AMENDED COMMUNITY UNIT PLAN FOR
THE DUGAN CENTRE

Wichita-Sedgwick County Metropolitan Area Planning Department

The following reflects staff's approved text modification identified in red letters.

The following reflects the proposed modifications identified in red letters.

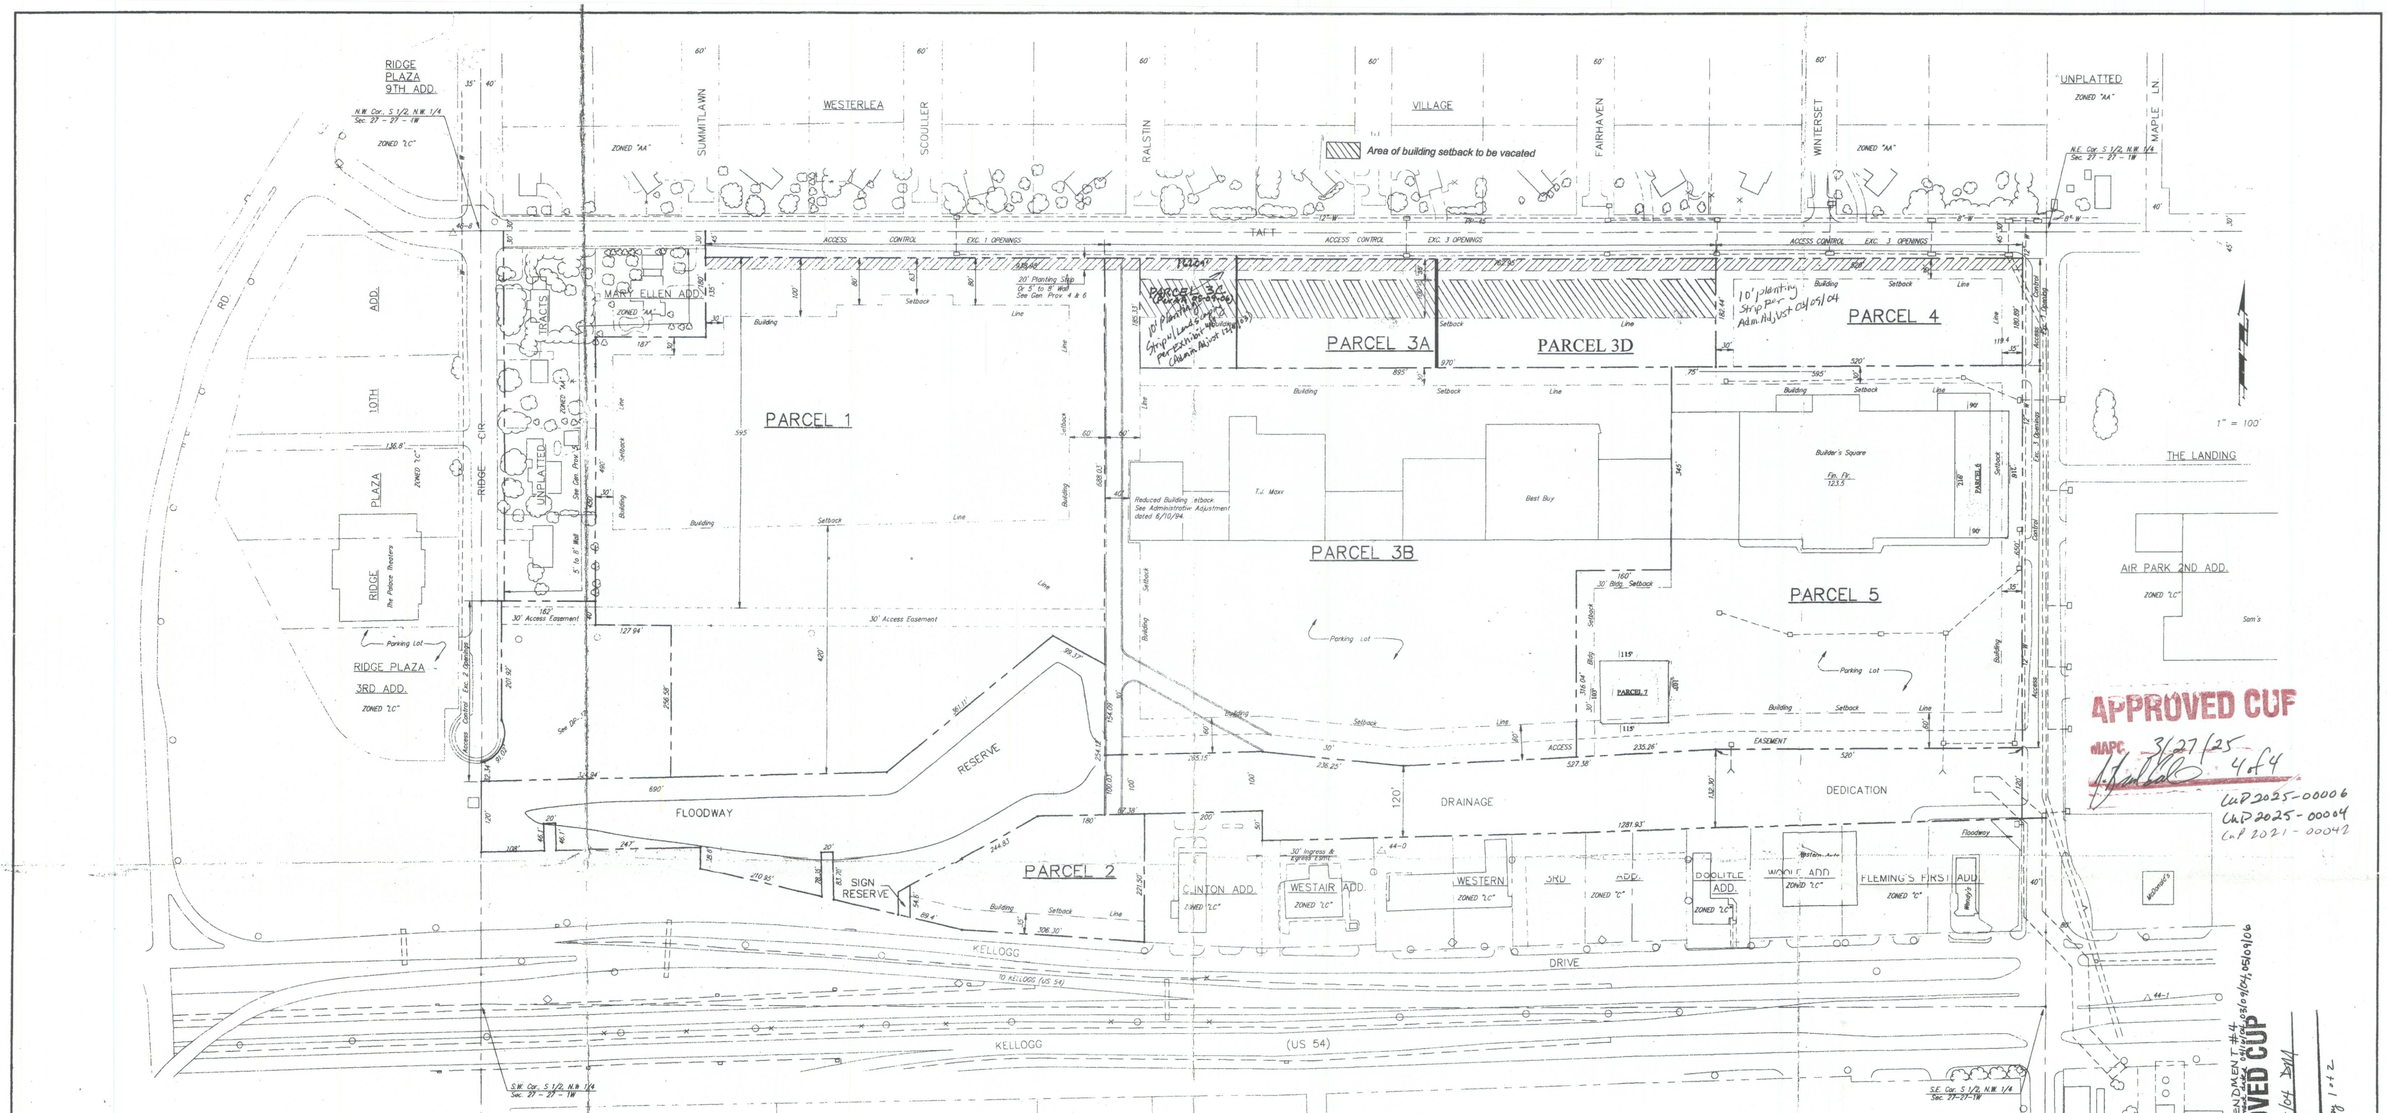
Section III-C.2.b.(2).(a).1. of the Unified Zoning Code (UZC) requires a minimum building setback of 35 feet from all street rights-of-way. The CUP was established with a 100-foot setback along West Taft Avenue. In 2023, the 100-foot setback was reduced to 35 feet (VAC2023-00020). It was then further reduced to 25 feet as discussed above. The possible negative effects on nearby properties as a result of the setback vacation was considered by the Metropolitan Area Planning Commission. It was determined at that time that there would be no significant negative impacts to nearby properties as a result of the reduced setback.

On the basis of our review, we find that adjusting the CUP in the manner stated above is consistent with the approved CUP and will not have an adverse effect on the CUP or adjacent properties, nor will it be a substantial deviation of the original plan. The requested reduction in the setback to 25 feet, except for the

west 40 feet, for the proposed commercial use on Parce 3D is not likely to have significant detrimental impacts on nearby properties. The nearest residential properties are separated from the site by West Taft Avenue.

A. Net Area: 71,118.61 sq. ft or 1.63± acres
B. Maximum building coverage: 28,447.44 sq. ft or 40%
C. Maximum gross floor area: 28,447.44 sq. ft
D. Floor area ratio: 40 percent
E. Maximum number of buildings: 4
F. Maximum building height: 35 feet
G. Setback along Taft: 25 feet, except 35 feet along the west 40 feet
H. Parking Per UZC
I. Access points to Taft: 1

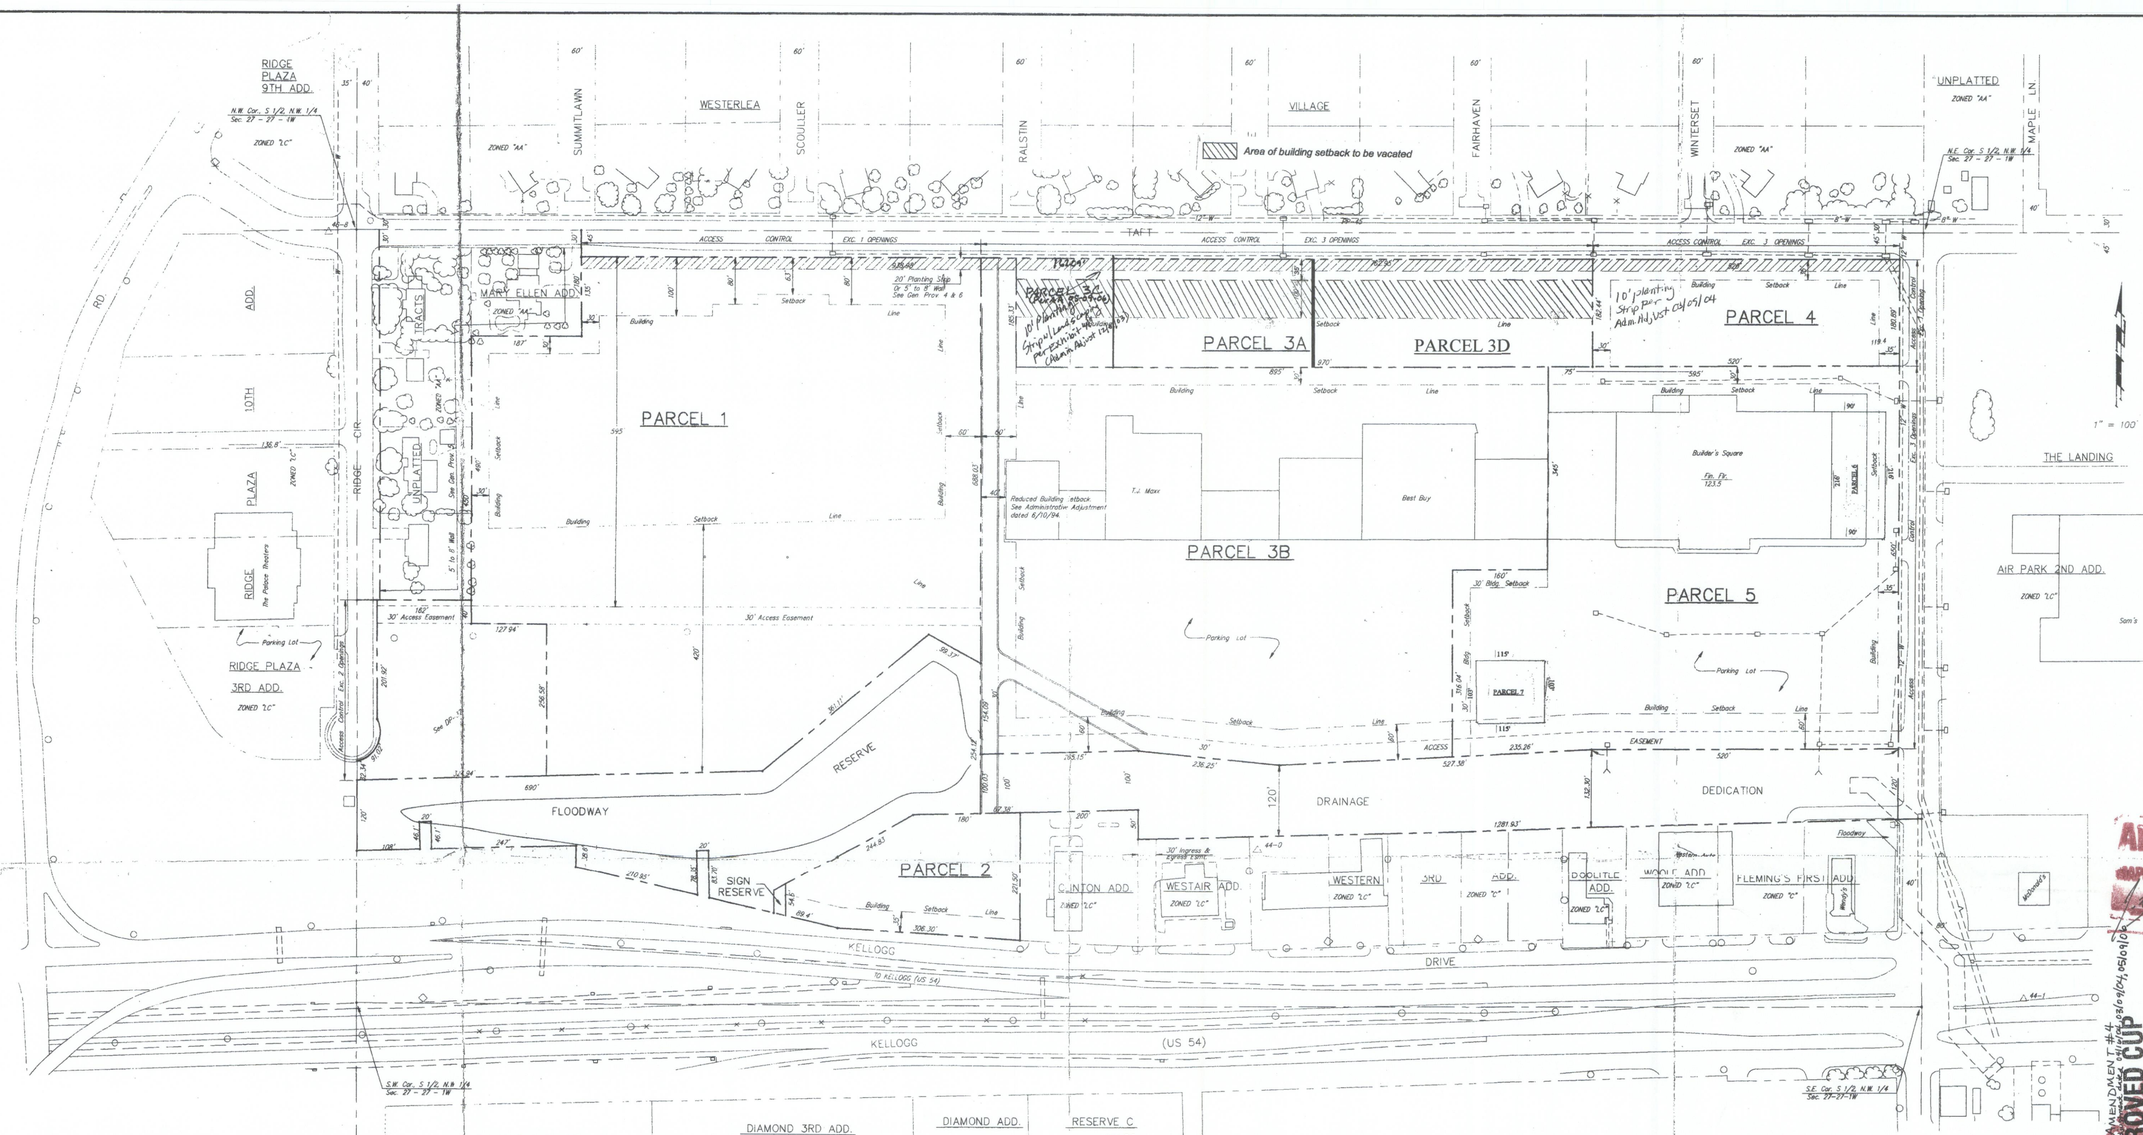
On the basis of our review, we find that adjusting the CUP to permit building signs on the north elevation of a portion of Parcel 1 is consistent with the approved CUP and will not have an adverse effect on the CUP or adjacent properties, nor will it be a substantial deviation of the original plan. General Provision 4 requires a 20-foot planting strip along West Taft Avenue. Within this planting strip are mature trees. Additionally, the distance from the sign face to the nearest house on the north side of West Taft Avenue is approximately 294 feet. Within the North right-of-way of West Taft Avenue are additional mature trees. The combination of vegetation and distance help mitigate possible negative impacts of illuminated building signs. Since 2012 when the initial sign was permitted and installed, there have not been any complaints submitted by the residents on the north side of West Taft Avenue.

E. No building signs shall be permitted on the north side of any building along Taft Avenue in Parcel 1, provided that each tenant located within the building addressed as 6920 West Kellogg is permitted one building sign up to 64 square feet in area along the north elevation.
